REMARKS

EXHIBIT A: Replacement Sheets for FIGS. 3 and 8

EXHIBIT B: Annotated Sheets showing changes made to FIGS. 3 and 8

IN THE DRAWINGS

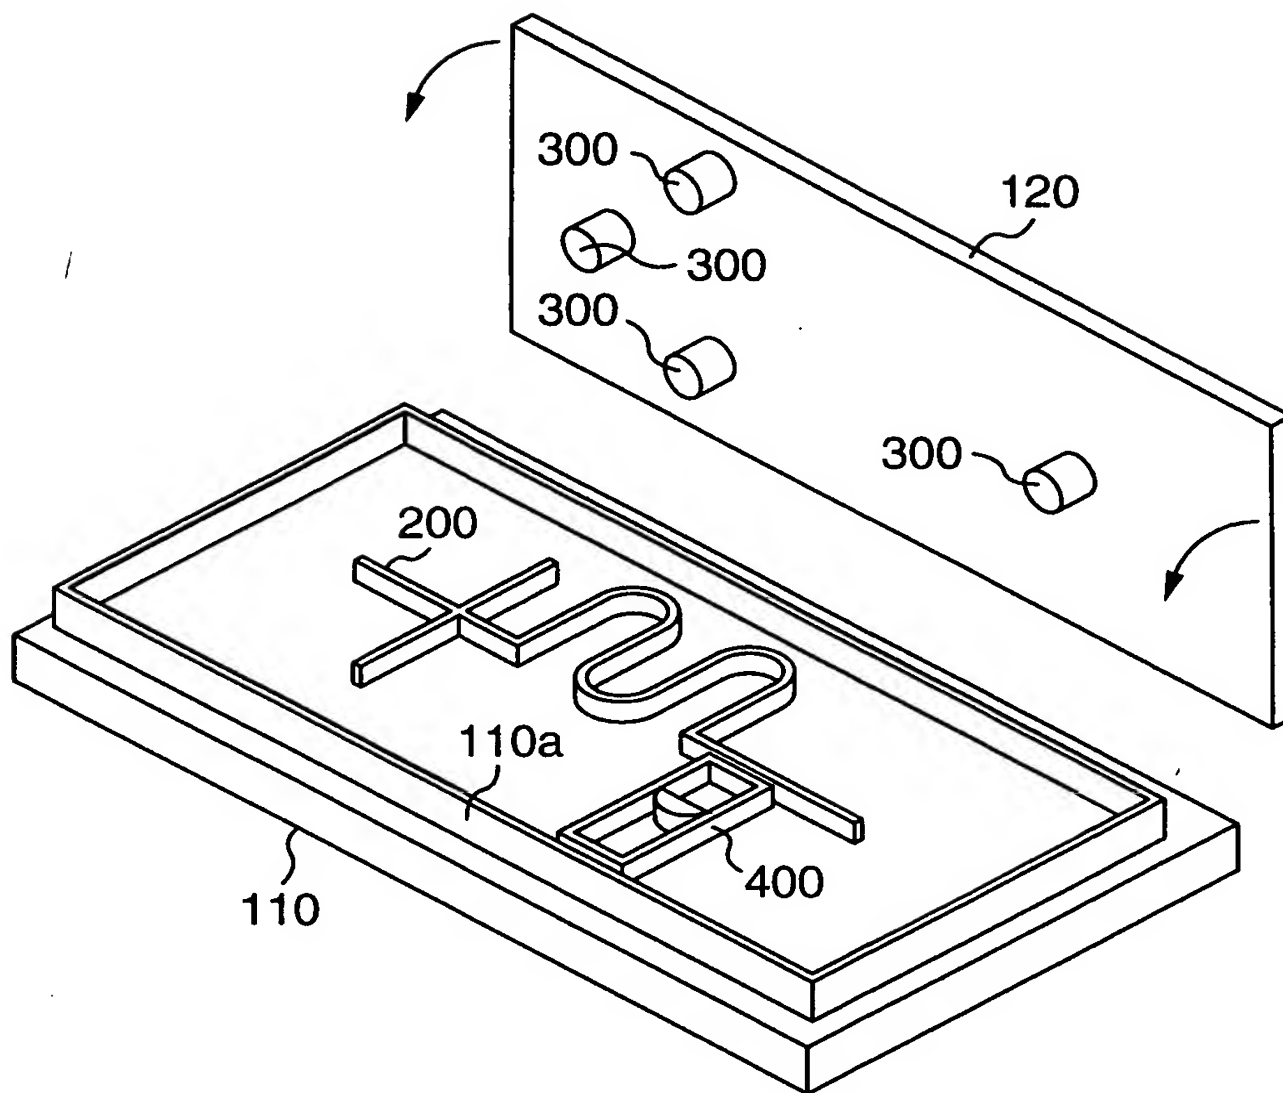
The drawings have also been objected to as failing to comply with 37 C.F.R. §1.84(p)(5) because reference signs 1200, 1900, 2000 and 2100, as shown in FIG. 8, were not described in the specification. In response thereto, the specification has

been reviewed, and FIG. 8 has been revised to delete those reference signs, which are not material to the patentability of claims 1-11 as pending in the application, in order to place the application in condition for allowance.

RELATED ART
FIG. 3

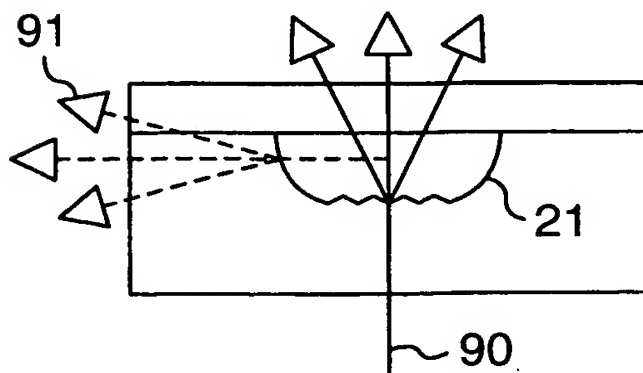
The drawings have been objected to because FIG. 3 is not designated by a legend such as "Prior Art." However, this objection is incorrect. FIG. 3 is not believed to constitute "prior art" as that term is defined by either 35 U.S.C. §102 or 35 U.S.C. §103. Rather, FIG. 3 is simply an abstract representation of the art prepared by Applicants in an effort to illustrate Applicants' discovery of problems plagued in the art; this discovery is itself, together with Applicants' abstraction of the art represented by FIG. 3, part of Applicants' invention. FIG. 3 is therefore, Applicants' work products and Applicants' effort to describe his invention in terms of both the problems which have plagued in the art and which Applicants have addressed with the inventions defined by the claims. In view of these explanations, Applicants again trust that the objection will be withdrawn. Nevertheless, for purposes of expedition, FIG. 3 has been labeled as "Related Art" in order to place the application in condition for allowance.
